Sumter City-County Planning Commission

MSP-14-35/HCPD-14-25, 418 Broad St. – Cypress Gardens Dialysis Center (City)

I. THE REQUEST

III. SITE PLAN REVIEW

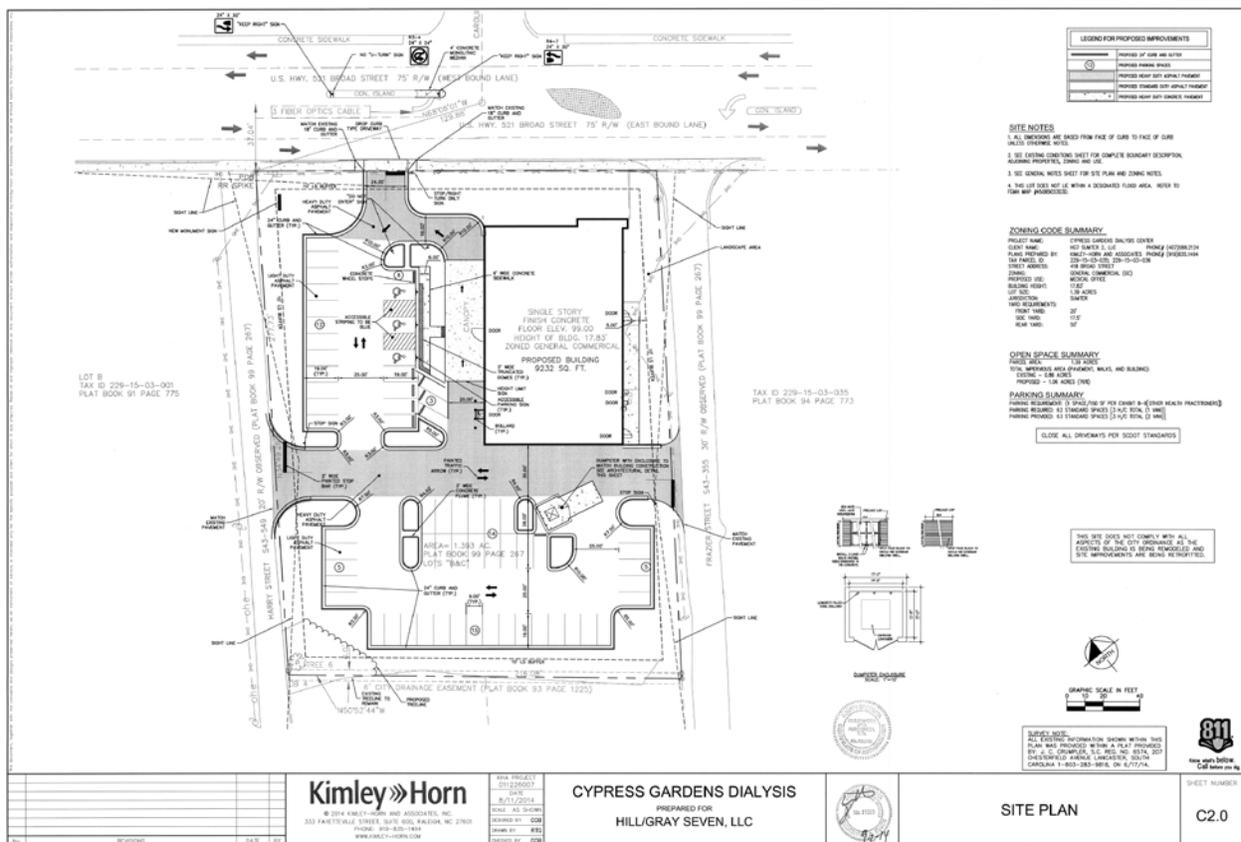
As per the requirements found in Article 8, Exhibit 8-9, the parking requirement for clinics are 2 per bed or 1 per 150 sq. ft. GFA (gross floor area) whichever is greater. Based on a building size of 9232 sq. ft. the development is required to have 62 parking spaces, 3 of which must be handicap accessible. The submitted plans make accommodation for 59 standards parking spaces, 1 standards ADA space and 2 ADA Van Accessible Spaces for a total of 62 parking spaces.

The parking plan depicts a combination of 90° parking and angled spaces. The proposed aisle widths meet the minimum requirement of the Ordinance. Based on the proposed parking lot layout, site flow should be sufficient.

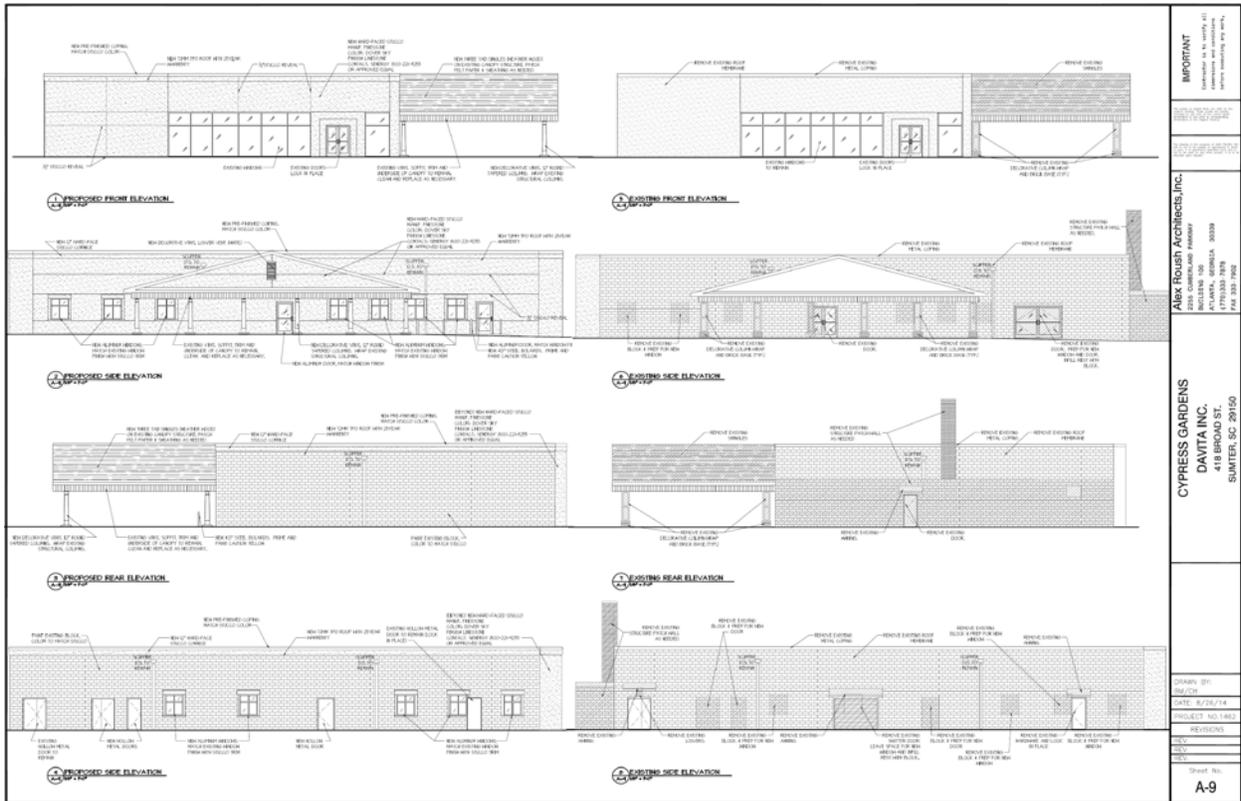
- a. If a new commercial building is proposed, not more than sixty percent (60%) of the facade facing a street may be glass or reflective materials;*

This is an existing structure with proposed exterior renovations.

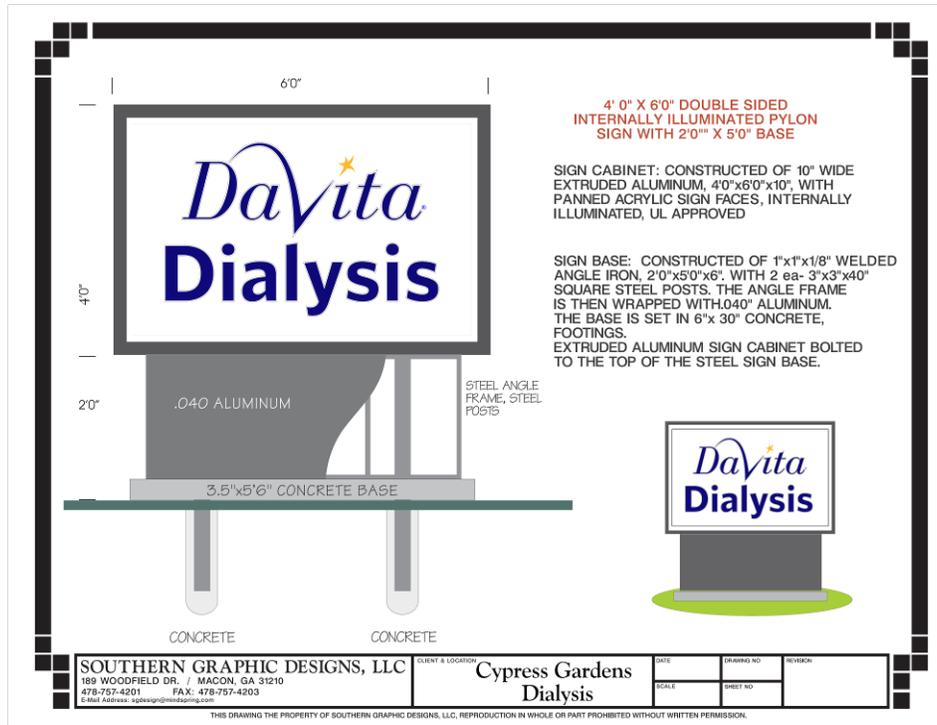
The building is proposed to have façade upgrades to include new window and door openings, paintings, and stucco work as shown on the following page.

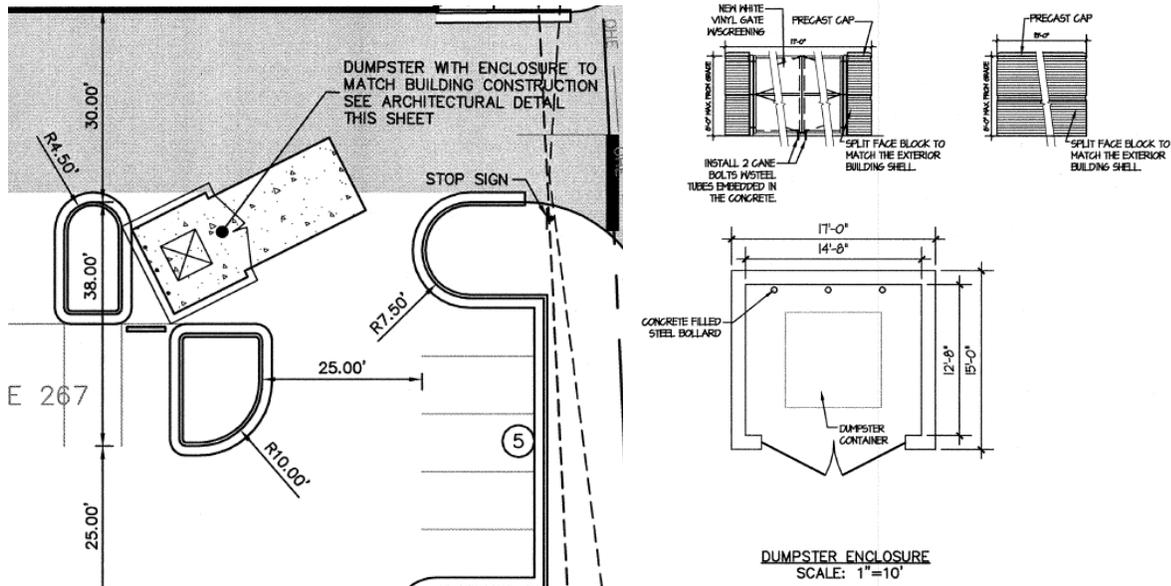
f. All proposed fences and / or walls proposed for the front and / or side yards shall be reviewed as part of the Highway Corridor Design Approval Request.

The applicant has submitted the dumpster screening plan shown below.
